**Device**            **XC822/824MT Series**  
**Marking/Step**   **AA**  
**Package**         **PG-TSSOP-16/DSO-20**

This Errata Sheet describes the deviations from the current user documentation. The module oriented classification and numbering system uses an ascending sequence over several derivatives, including already solved deviations. So gaps inside this enumeration can occur.

This Errata Sheet covers the following devices:

**Figure 1 Counting sequence of T12 in center-aligned mode**

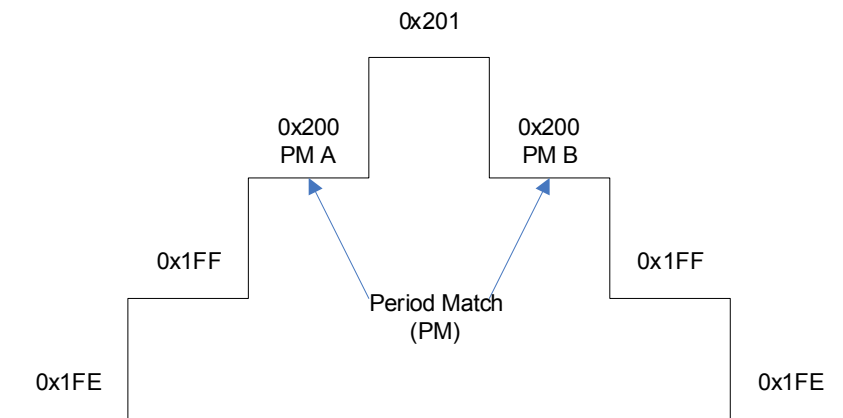
**CCU6\_XC8.H002 CCU6 PM event in center-aligned mode**

After detecting a period match (PM A) in centre-aligned mode, T12 counts down from PM + 1 as shown below:

This means a second PM event (PM B) will occur during the counting down. If ADC is triggered externally via REQTRxC (T12PM), it will be triggered twice in succession. Depending on how real-time the application code is running as well as the T12 count rate and ADC conversion rate, the application could observe two ADC interrupts - once at PM A and once at PM B.

To avoid triggering twice the ADC interrupts, it is suggested to use REQTRxF from multi-channel mode instead of REQTRxC as the trigger source for ADC. Additional initialization are as follows:

- Configure MCMCTR.SWSEL = 101<sub>B</sub> (Transfer on T12 period match)
- Configure MCMCTR.SWSYN = 00<sub>B</sub> (Direct transfer)
- Write to MCMOUTSTL = CF<sub>H</sub> (To enable multi-Channel PWM pattern on CC6x and COUT6x)
